CONDITIONS OF APPROVAL:

Engineering - Final Plat Checklist

195870-Gothic Ct Subdivision-FINAL PLAT.pdf

13. C. Final Plat

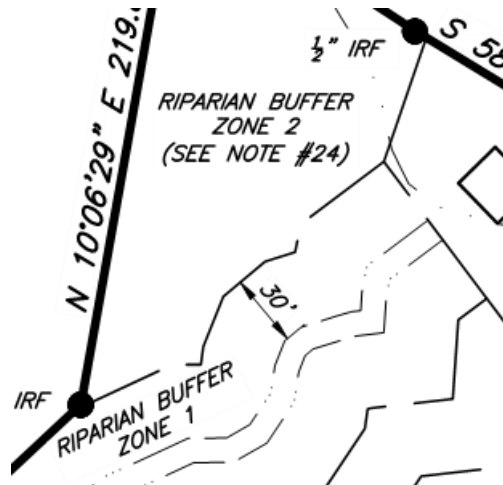
lance.fittro@franklin.tn.gov The previous comment, "*Applicant shall clarify the intent of the parking easements shown on the plat. Who is the beneficiary of the easement area? Who is responsible for maintenance? Is there an associated shared parking agreement?*" has not been addressed appropriately.

Applicant shall clarify ownership, intent for use, and maintenance responsibilities for the parking areas shown within the open space lots being created on the plat.

20. Plats

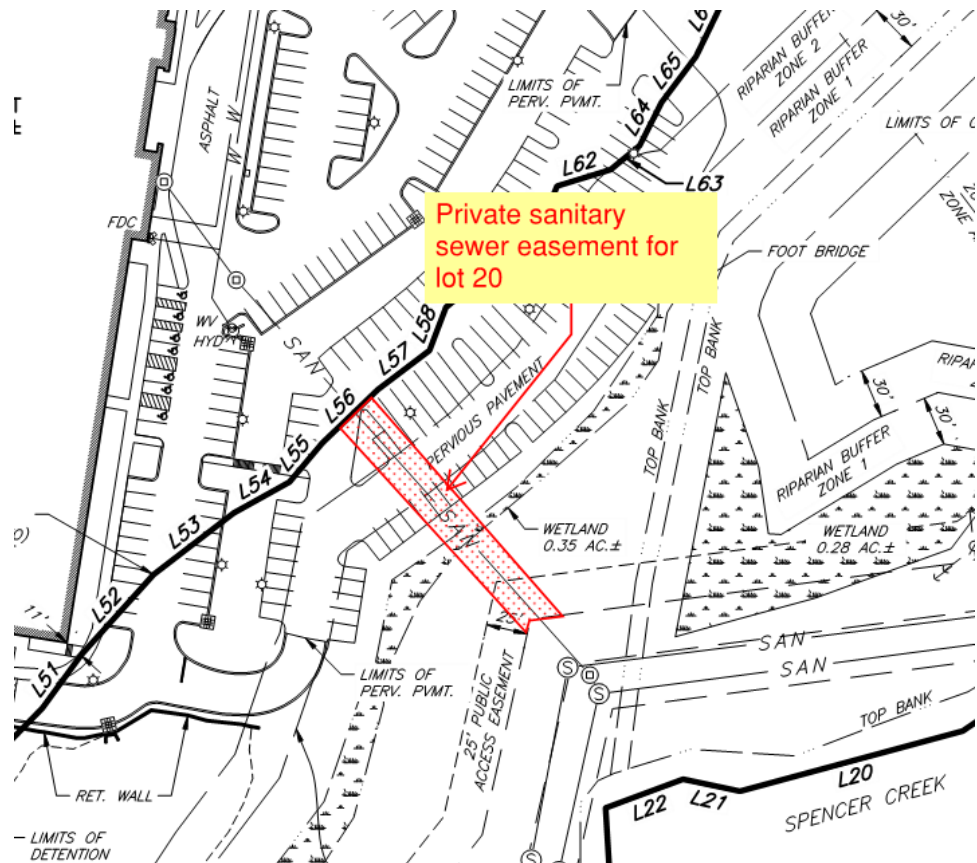
jeff.willoughby@franklin.tn.gov Comment not entirely addressed. Any offsets to riparian buffers must be approved through a variance submittal process. Please contact me at 550-6651 or jeff.willoughby@franklin.tn.gov for details.
